UNITED STATES PATENT AND TRADEMARK OFFICE

APPLICATION NO.	FILING DATE	FIRST NAMED INVENTOR	ATTORNEY DOCKET NO.	CONFIRMATION NO.
10/087,320	03/01/2002	Andrew H. Cragg	BSI-030US7	3784

Office Action Summary

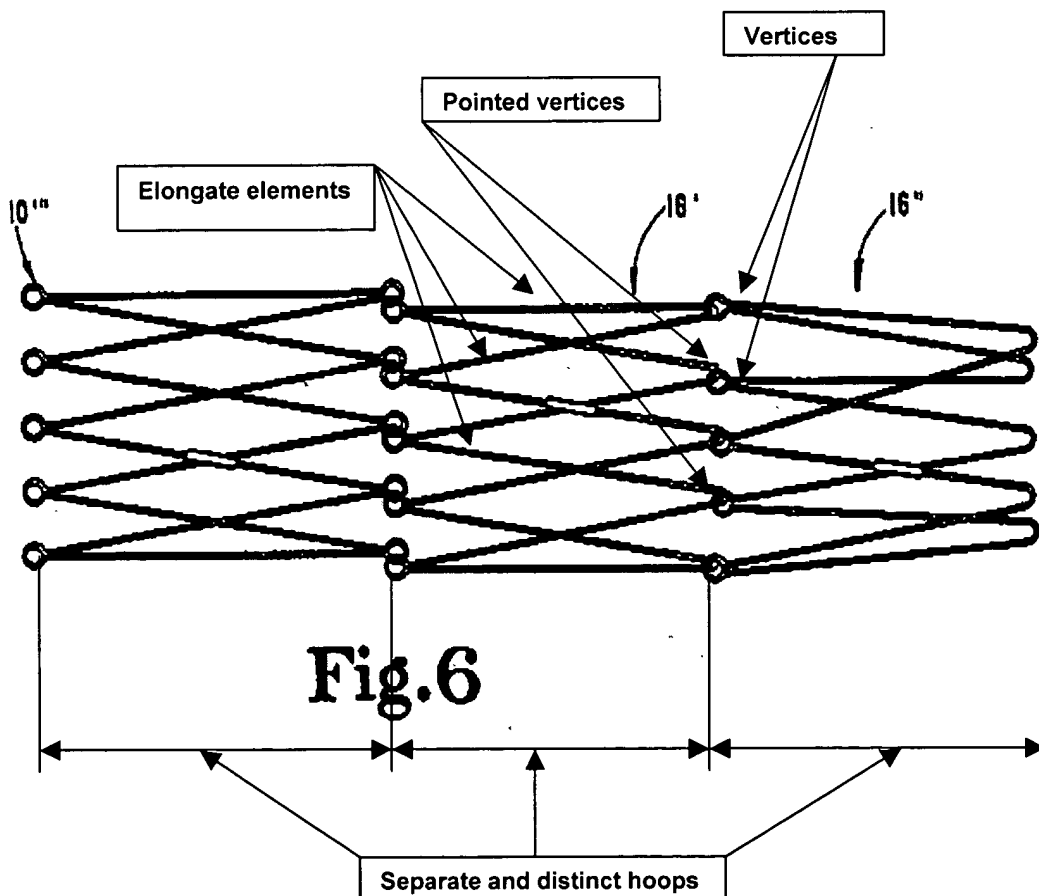
As to claims 10-11, 13-15, BARONE (Fig. 2-4; column 6, lines 32-45) discloses a stent-graft combination including graft member 160, stent member 166/172 of stainless steel having diamond shaped openings to define elongate elements, with pairs of the elongate elements forming vertices. The vertices axially abut and are individually connected to the opposite pointed vertices. Notice that stainless steel is a resilient and shape memory material. BARONE Fig. 3 also shows graft 160 covers stent 166/172. BARONE does not disclose a stent structure having separate and distinct hoops as recited in the claims. However, to provide a combined stent that permits the combination of several interlocked separate and distinct hoops for insertion into a body passageway without multiple catheterization, GIAN TURCO (lines 20-24, col. 2) discloses a stent having separate and distinct hoops and vertices connected together in a manner as recited in the claims and as shown in the Fig. 6 below:

In view of GIANTURCO, it would have been obvious to one of ordinary skill in the art at the time the invention was made to construct a stent-graft combination as claimed by replacing BARONE stent structure with GIANTUREO stent structure of stainless steel so as to provide a longer combined stent of connected shorter stents/hoops, which does not require multiple catheterization (or to avoid a multiple catheterization if the shorter hoops/stents are not connected) for deployment into a blood vessel (GIANTURCO: lines 20-24, col. 2).
